Product/Process Change Notice - PCN 23_0172 Rev. -

PCN Title:	Qualification of an Additional Substrate Supplier, SMT Attach Material and Pillar Size Change for LT8650S
Publication Date:	28-Aug-2023
Effectivity Date:	30-Nov-2023 *(the earliest date that a customer could expect to receive changed material)*
Revision Description:	Initial Release.

Qualification of an Additional Substrate Supplier, SMT Attach Material and Pillar Size Change for LT8650S

Thermal Analysis Summary

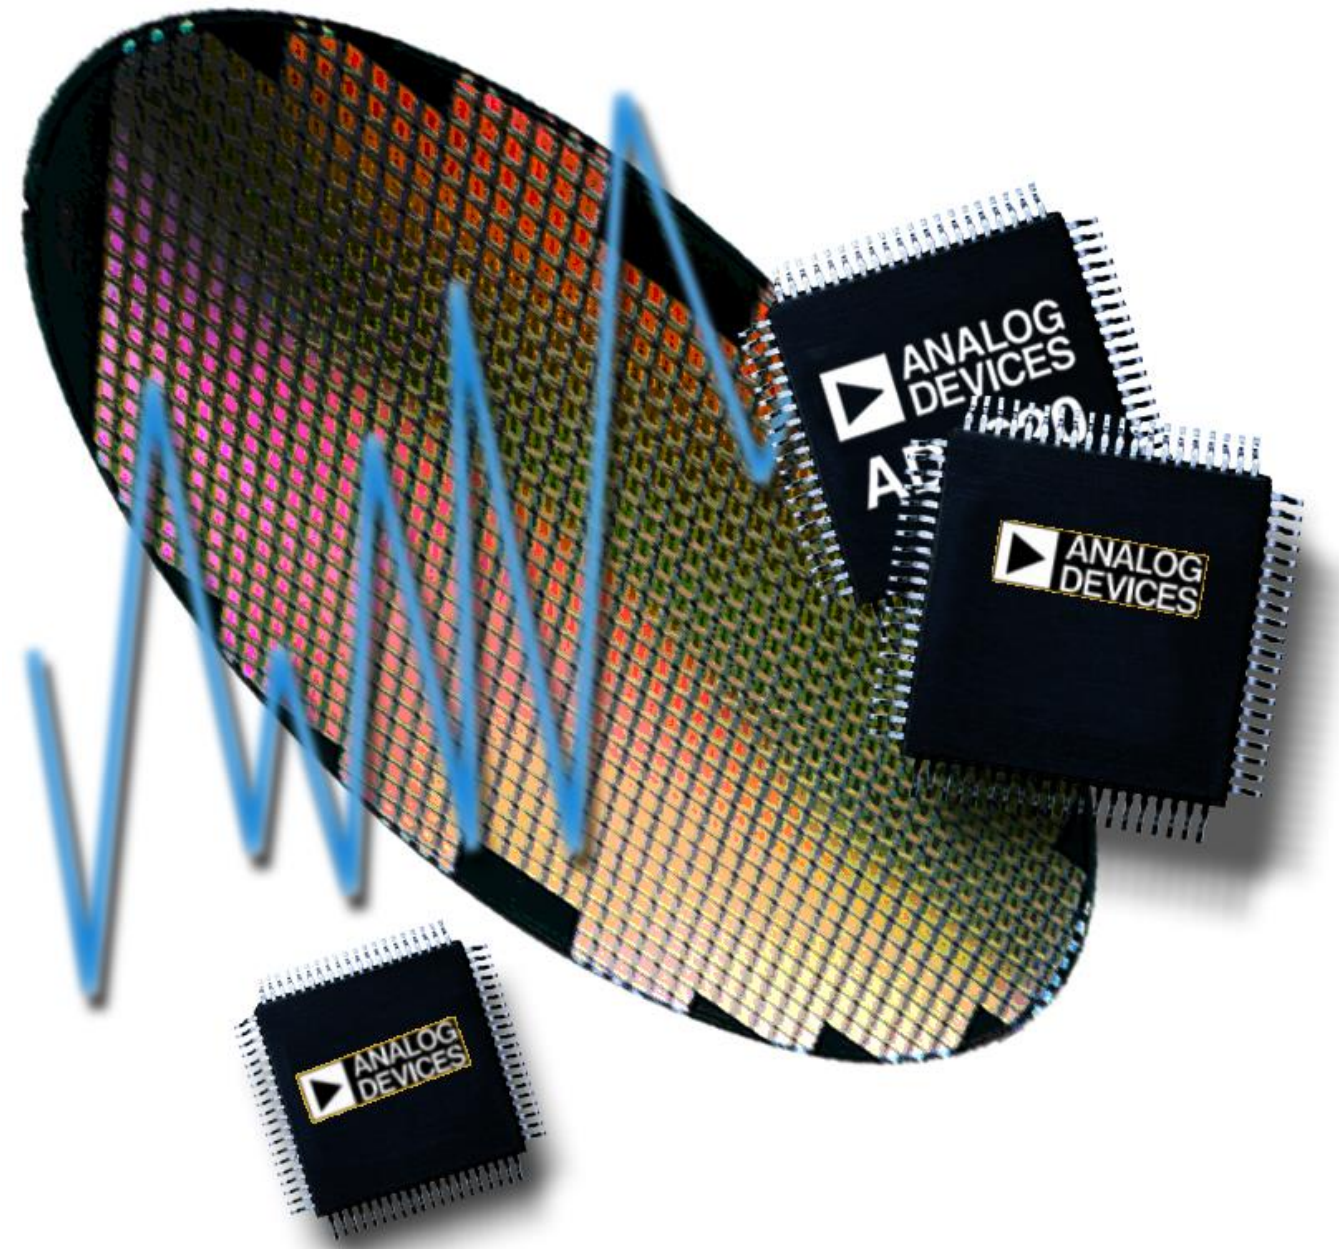
PCB:	4L Demo Board				
Device:	LT8650S	$T_{ambient}$ (°C) =			
Die thickness (mm)	Die	P_{loss} (W)	θ_{JA} (K/W)	θ_{JCtop} (K/W)	θ_{JCbot} (K/W)
0.2	U1	3.8	16.18	30.24	4.92
0.45			15.71	18.79	4.45
	Total Power:	**3.8**
